**NOTICE OF TYPE II DECISION**  
**MINOR LAND PARTITION (MLP) 2004-00001**  
**BIANCHI MINOR LAND PARTITION**

**FILE NAME:** **BIANCHI MINOR LAND PARTITION**  
**CASE NOS:** **Minor Land Partition (MLP) MLP2004-00001**  
**Adjustment (VAR) VAR2004-00006**

**LOCATION:** 13875 SW 121<sup>st</sup> Avenue; 2S103CC, Tax Lot 402.

**FIGURE 18.795.1  
ILLUSTRATIONS OF VISUAL CLEARANCE REQUIREMENTS**

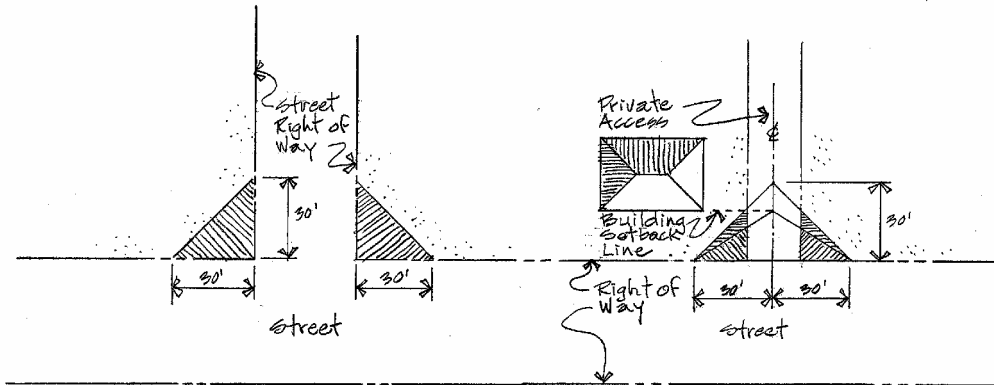
The applicant has indicated there are no visual obstructions between three and eight feet within the visual clearance triangle. Coordination with the City of Tigard during the widening of SW 121<sup>st</sup> ensured that the associated retaining wall met the visual clearance standards. However, the applicant is still required to provide a plan showing the visual clearance triangles on either side of the private street entering the property to be clear of obstructions between three and eight feet.

**CONDITION:** Provide a plan showing the visual clearance triangles on either side of the private street entering the property to be clear of obstructions between three and eight feet.
